Re:- Plot No 58 M.M.6. Machhi Miani Qr.

**KARACHI MUNICIPAL CORPORATION.****BUILDING SECTION.****REVIEW FORM.**

Case No. P/Q 507/26.

SHOWING PROPOSED GARAGES ON PLOT N^o 58. SHEET. M.M.G.
MACHNI MIANI QUARTER

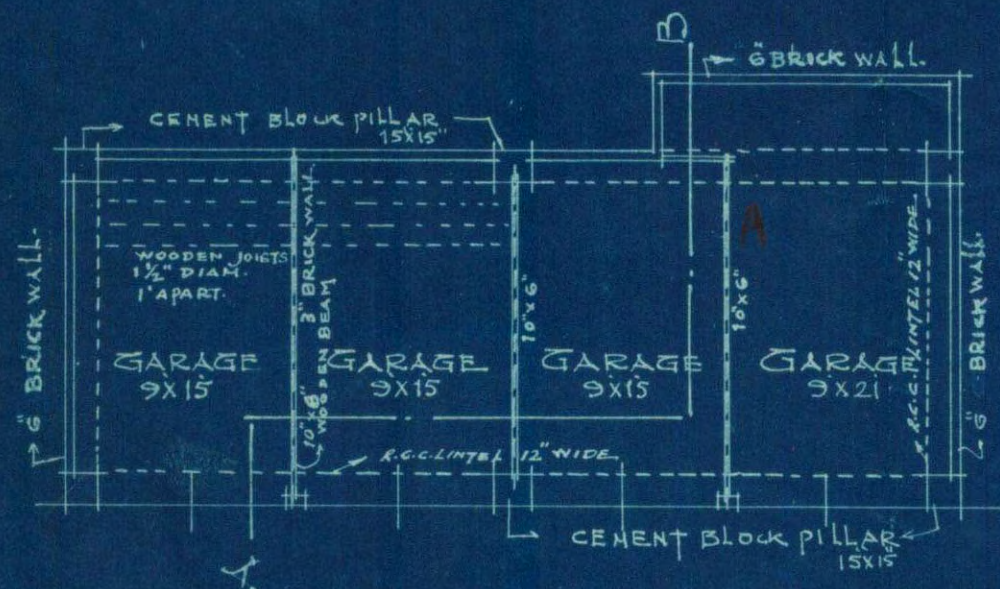
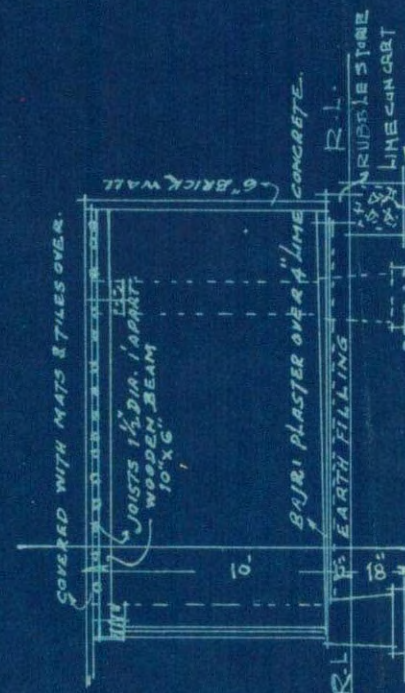
Street widths require to be shown - also the opposite street line.

- 1. Title deed be produced.
 - 2. Reinforcement of pillars be given.
 - 3. Order be requested if 6" thick walls for exterior & 3" for interior partitions can be allowed.
 - 4. Ramp be provided in owner's own limit.
 - 5. On what beam marked A will not require to be mentioned
- RMH
13/8

1. Street widths require to be shown and also the opposite the street line.
2. Title deed must be produced
3. Reinforcement or ^{lintels} pillars be given.
4. Ramp be provided in owners own if it
5. On what beam marked A will rest requires to be mentioned.
- 6.

All requirements com-
 plied with except as re-
 gard the ramp (Reg. no. 2)
 Instead, the flight has been
 lowered and it is proposed
 6" at one end and 4" at
 the other. Orders are requir-
 ed if this be allowed &
 a ramp is provided it will
 be on M.F. land which can-
 not be allowed.

1. Plinth less than 1' cannot be allowed. Arrangement for a ramp in your own building must be made.

Sita plan is wrong and with f
of the street also is not given.

1. Site plan is wrong and width of the street also is not given.

With ref. to your no 1356. SD/31
dated 15th instants, I have to inform
you that Object 1 and 3 are
completed with.

Re: - Object 1, the ramp will
be made in owner's limit and reduce
the length by 5' 6"

Re Object 2, regarding resting
of the beam B, it will be seen
that in fact on the wall shown
on the plan and other detail parts on
the Moh. Meas. No 4 shown on
the plan.

Re Object 2, the Sale deed
has not yet been received by the owner.
Other relevant documents will be produced
when ready.

Flight less than 1' cannot
 be allowed. Arrangement for a
 ramp in your own limits must
 be made.

With reference to your letter
No B.S.P. 502/36 dated 16th instt. We
have to inform you that the plinth
has now been shown 1' high as desired.
The cars will be taken by placing
wooden ramps as is being done everywhere
and as explained personally.

*Submitted for order to approve the
plans as the site plan has not been
corrected by the architect in this office today.
The width of street also shown. 6
17/11*
